Subject: City of Fitchburg Northeast Neighborhood Urban Service Area Amendment Request

**STATE OF WISCONSIN  
DEPARTMENT OF NATURAL RESOURCES  
DECISION TO AMEND THE DANE COUNTY  
AREAWIDE WATER QUALITY MANAGEMENT PLAN**

**Amendment to the Central Urban Service Area and Environmental Corridors - City of Fitchburg**

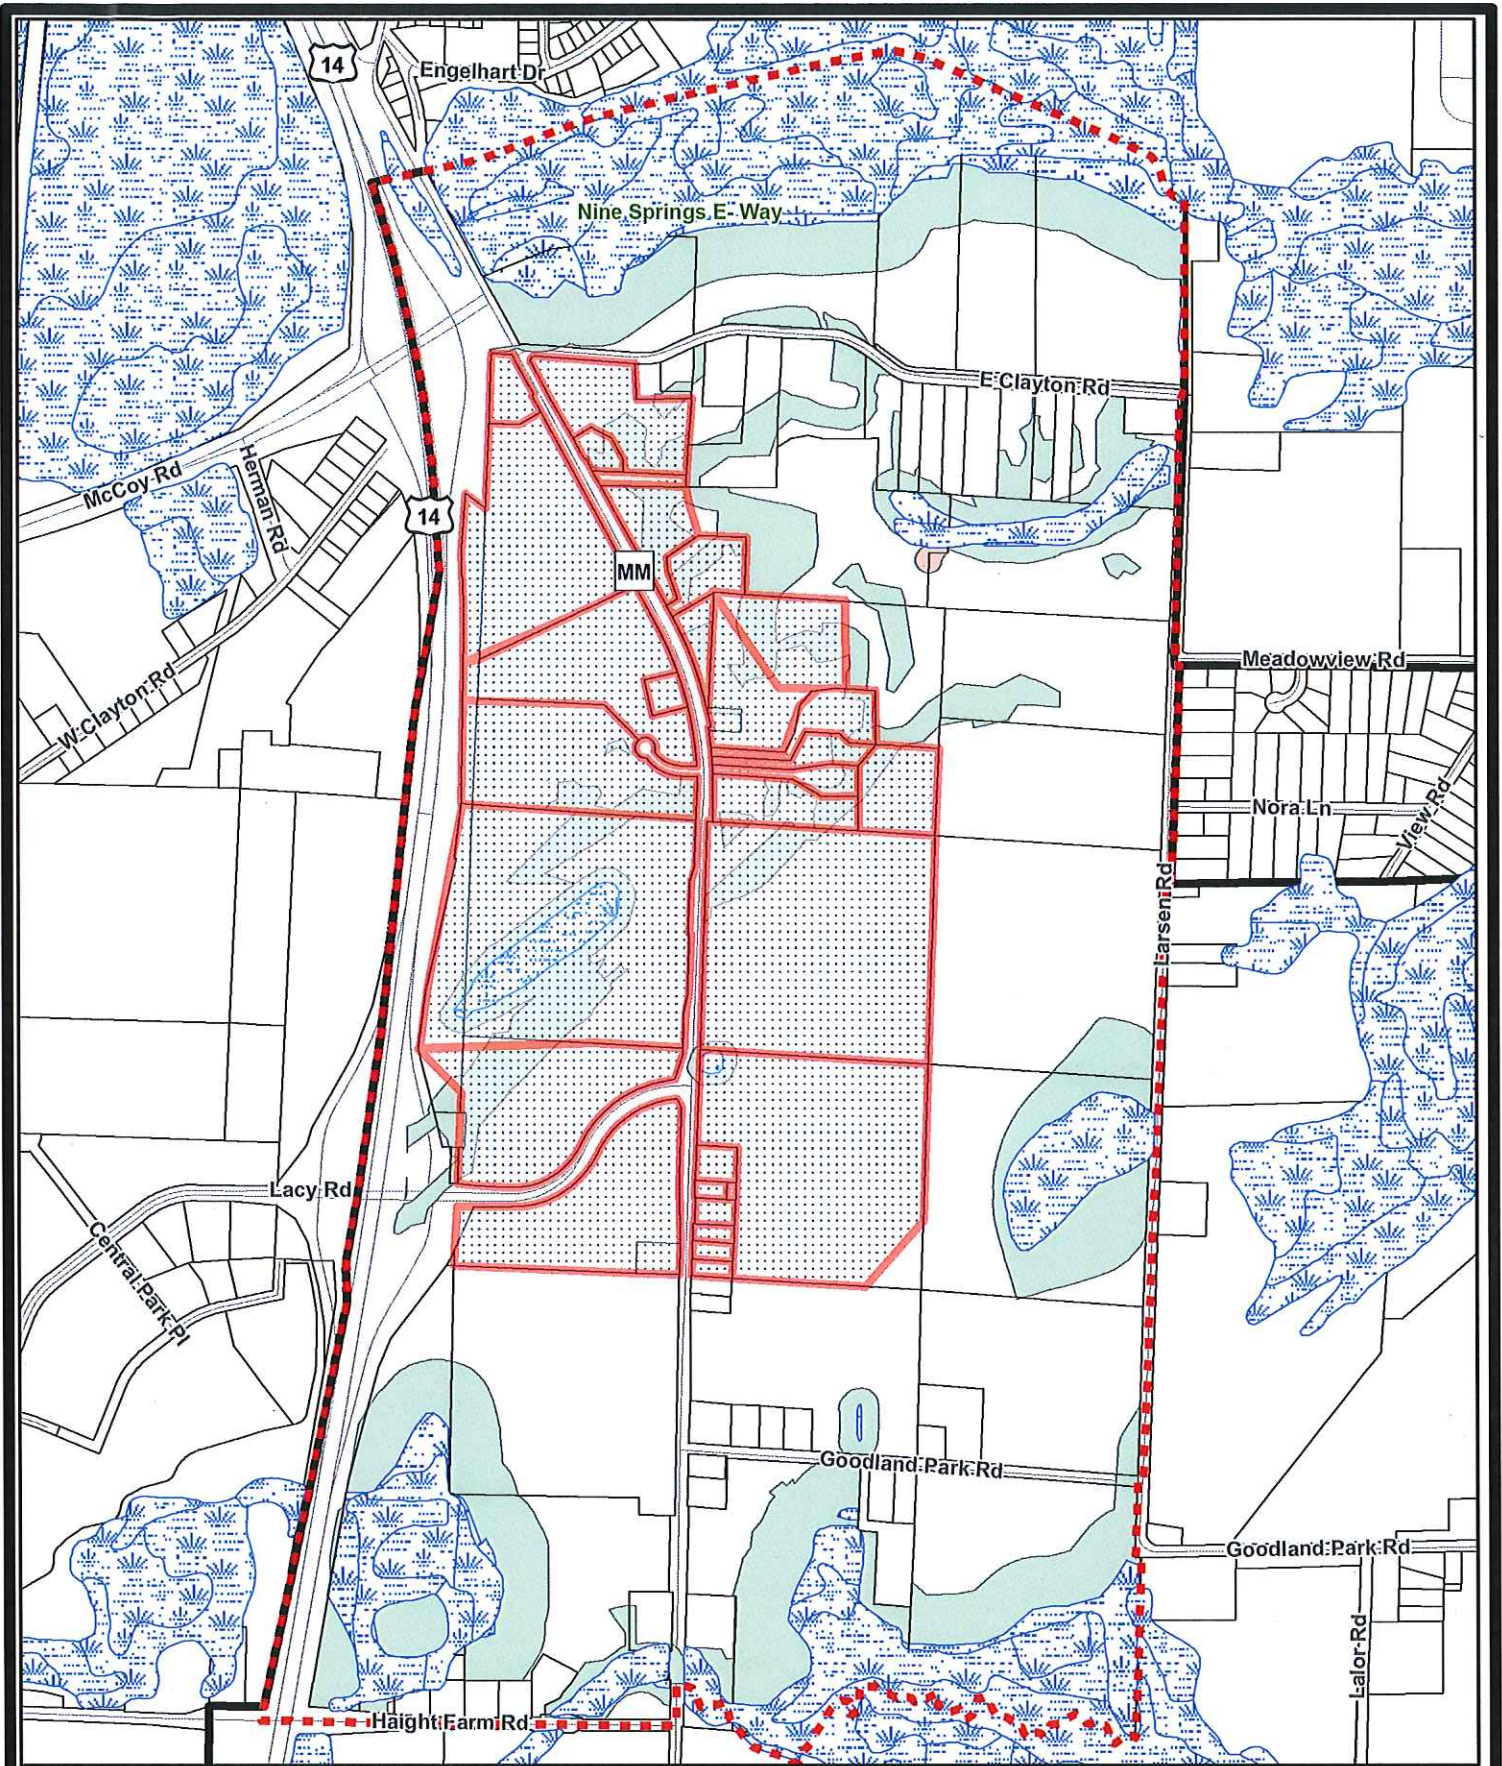
We partially approve your request for this amendment. We approve of Phase 1 and a portion of Phase 2a as outlined on the attached map. The map indicates areas that are approved for sewer service as well as the generalized areas identified as environmentally sensitive. We will issue an additional map refining the location and size of the pertinent environmentally sensitive areas in a subsequent communication.

*Phase 1 and the majority of Phase 2a (see description of amendment area) are approved for addition to the Central Urban Service Area for the City of Fitchburg with the following conditions.*

This amendment adds approximately 375 acres (includes both developable and nondevelopable land) to the City of Fitchburg's urban sewer service area, south of Highway 18/151 (south of East Clayton Road), east of Highway 14, west of Larson Road, and north of Goodland Park Road (see Attachment 1 - map of proposed urban sewer service area amendment). Fine scale analysis of environmentally sensitive area delineations both within the approval area as well adjacent to and downstream will be developed and published for the record and future decision making.

- Attachment 1 – Map of approved urban service area amendment lands and environmentally sensitive areas. Final environmentally sensitive area delineations will be published subsequent to this decision.
- Attachment 2- Summary of Public Comments Received and Response to Comments
- Attachment 3- List of Public Comments Received by WDNR between March 12 and April 3 2015
